Planning Scheme Amendment C196 – City North

29 April 2014

Planning Scheme Amendment C196 – City North

Amendment C196 to the Melbourne Planning Scheme

Figure 5 Framing of views out of the Haymarket

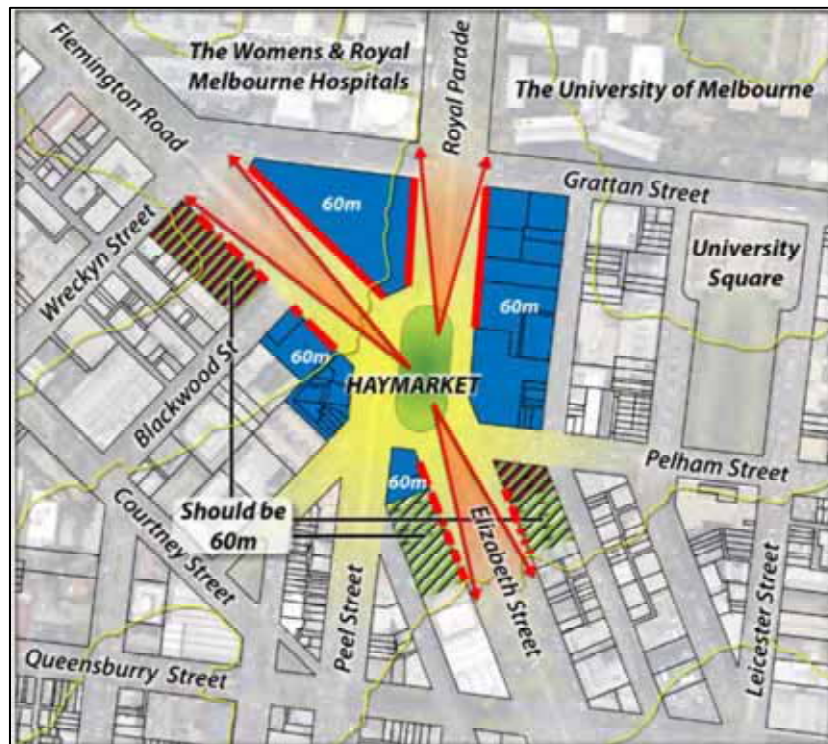
Ms Heggen used Figure 5 to note that:

‘built edge’ to this open space. Height is not the only technique needed to provide a sense of enclosure to this space. It also needs width of structure. There is more ‘width’ given over to road than there is to building edge

- *To close the axial views from the principal roads into the Haymarket with a firm and strong building edge the taller buildings around the Haymarket need to extend along Elizabeth Street, Royal Parade and Flemington Road on the immediate approach to the Haymarket. When they are seen in approach they will visually enclose and define an edge to the Haymarket.*

In relation to the extent of the Haymarket, the Panel accepts Ms Heggen's evidence which was assisted by Figure 5 that the Haymarket can be framed by taller buildings, and that this would assist with its enclosure and place development. However, in relation to the UAG's submission that its site should be included in Area 6, the Panel is not convinced that the

Post exhibition provisions for Area 2 presented to Panel

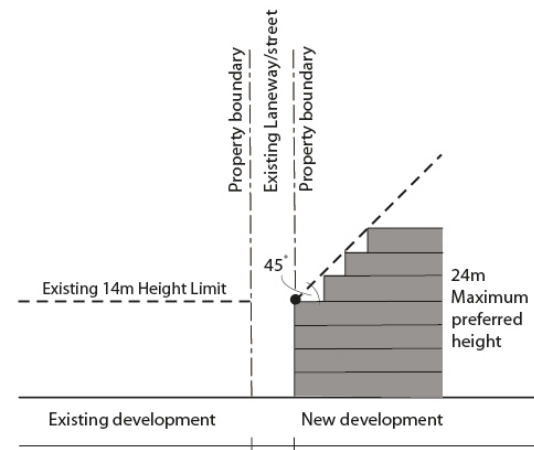
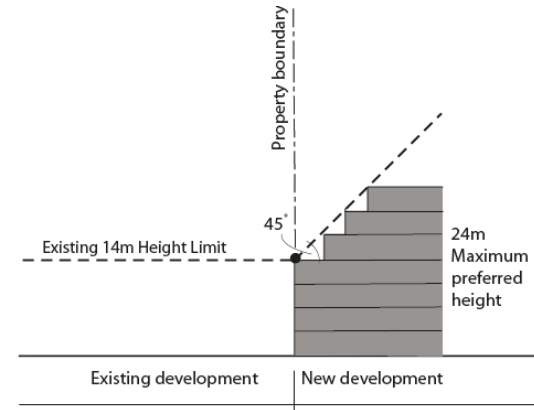
Concerned that no draft provisions in place to enable an appropriate transition of height to occur have been provided. This makes it very difficult to comment when this transition has not been defined.

It appears that this matter of appropriate transition has been resolved by the Panel in a manner which provided maximum flexibility for the developer and minimum protection for the residents.
